SHEET NO. 1.

M.D. LENNARD
B. ARCH. II
FIRST TERM.

PROPOSED GUEST HOUSE

WORKING DRAWINGS
SCALE : 1" TO 4' 0"
28TH JUNE 1947

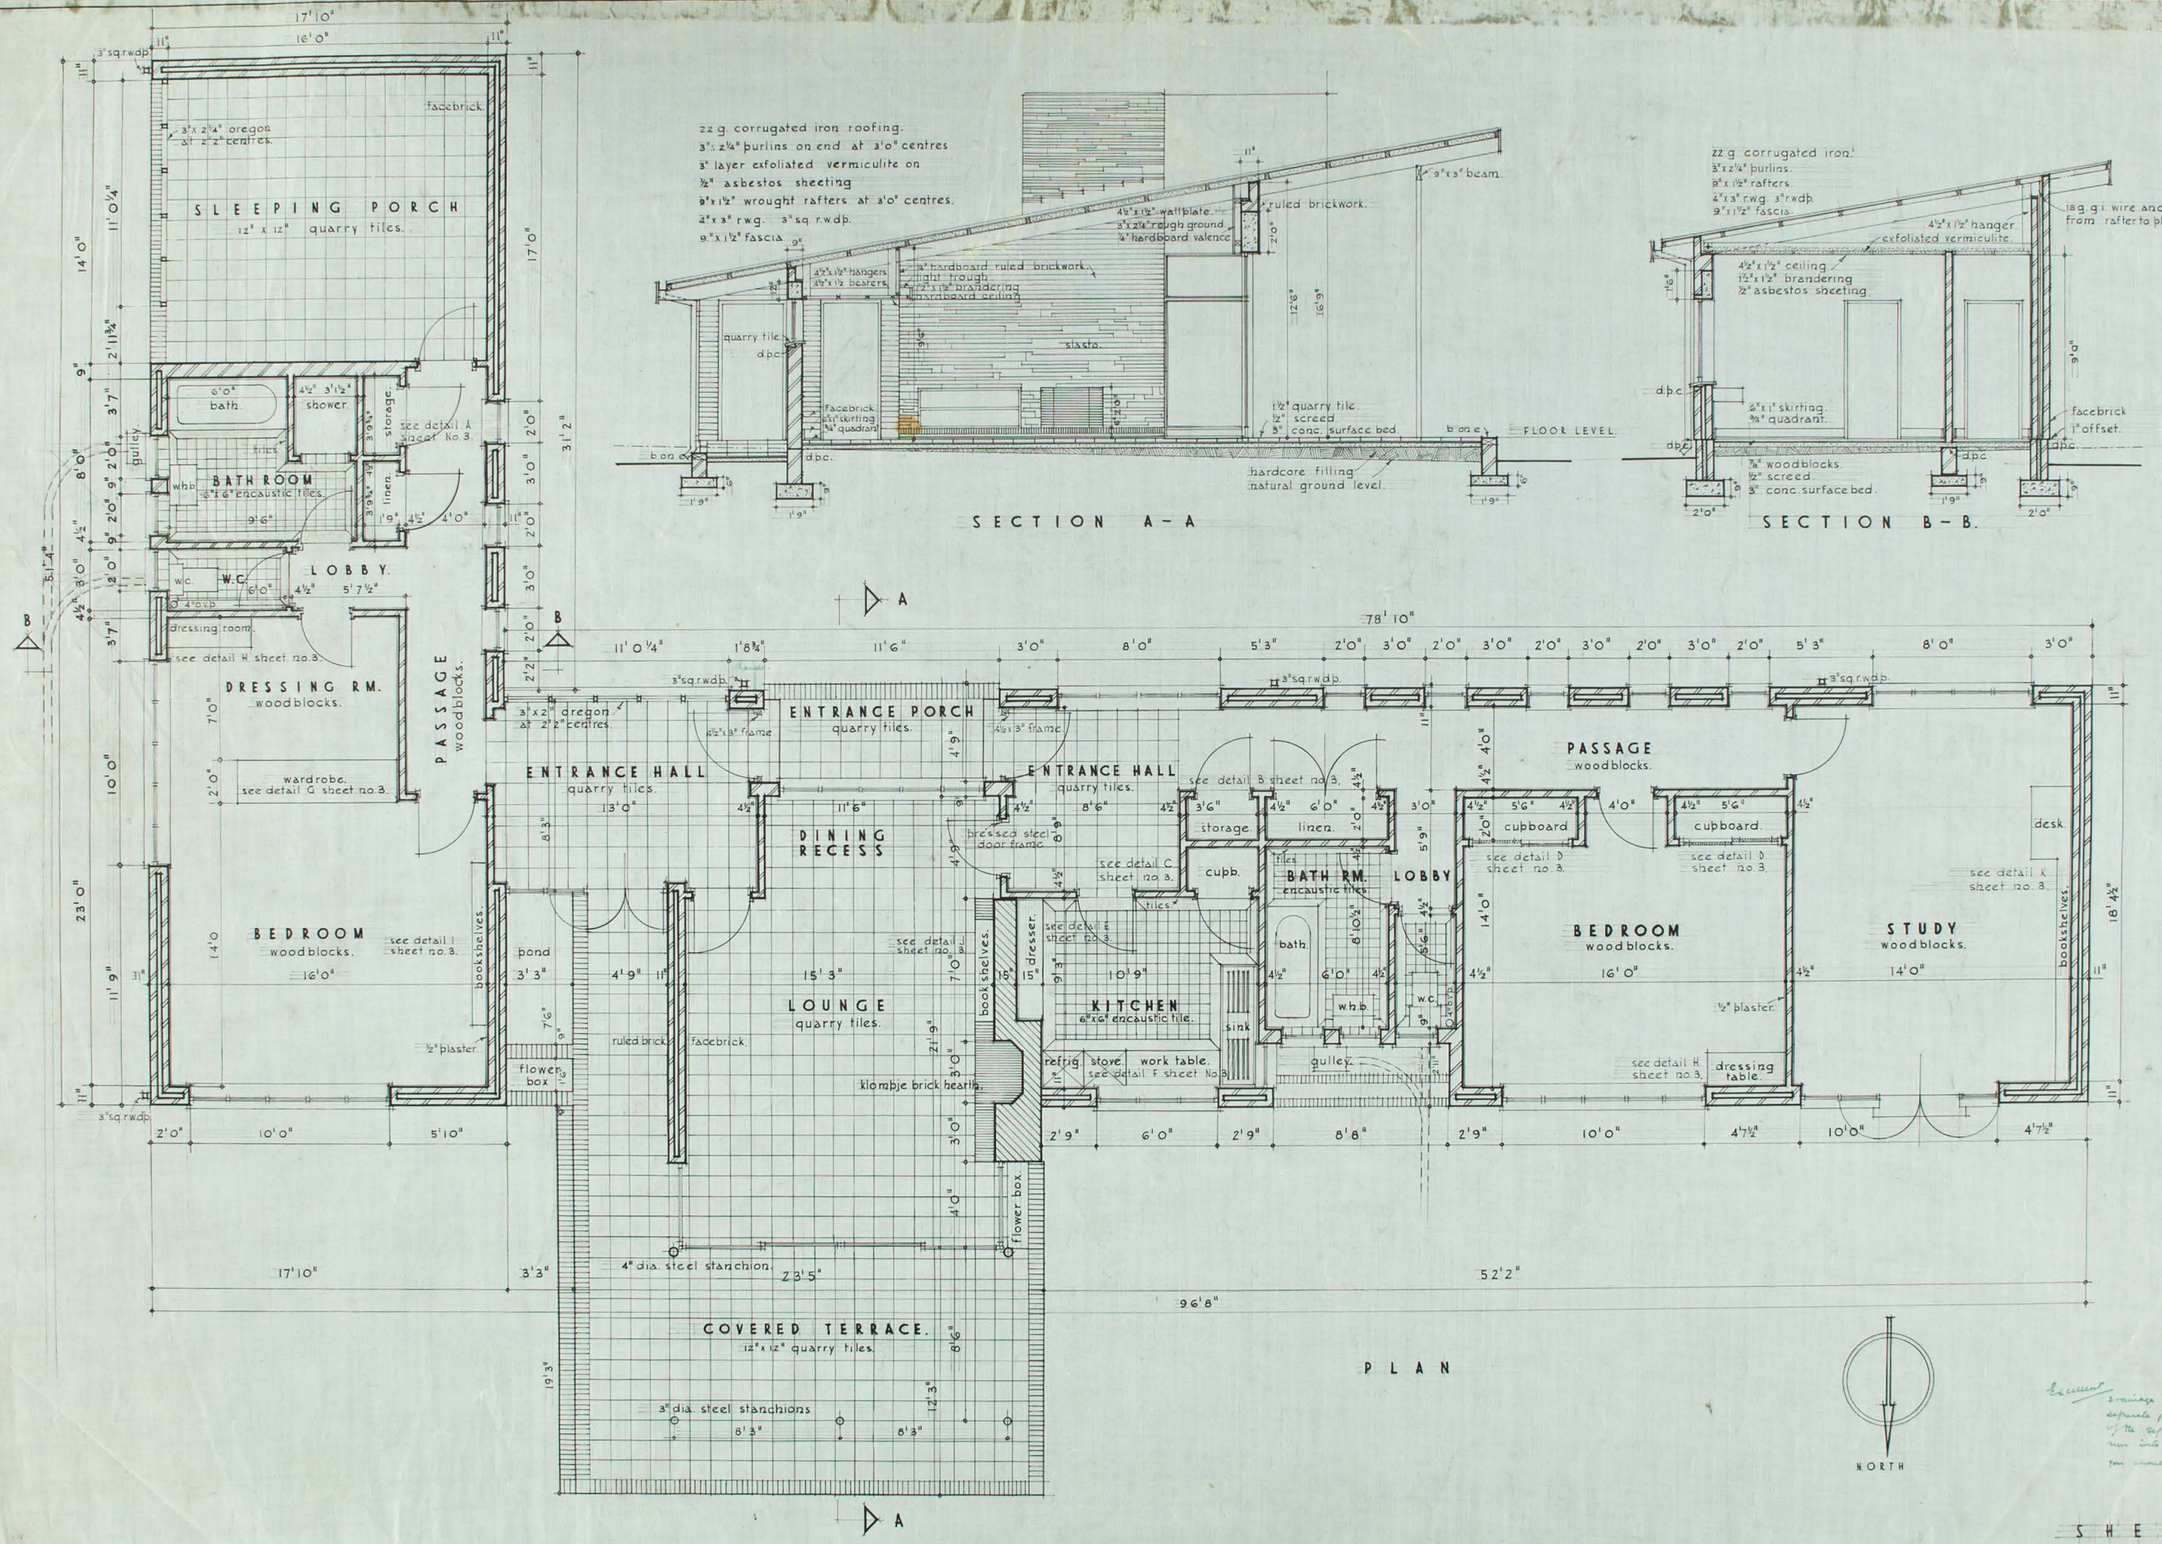
Excellent

Drainage system would have to be separate for waste water & soil in view of the septic tanks. B. waste water would run into a separate P.D.

You should show T.W. chamber & Plot of land
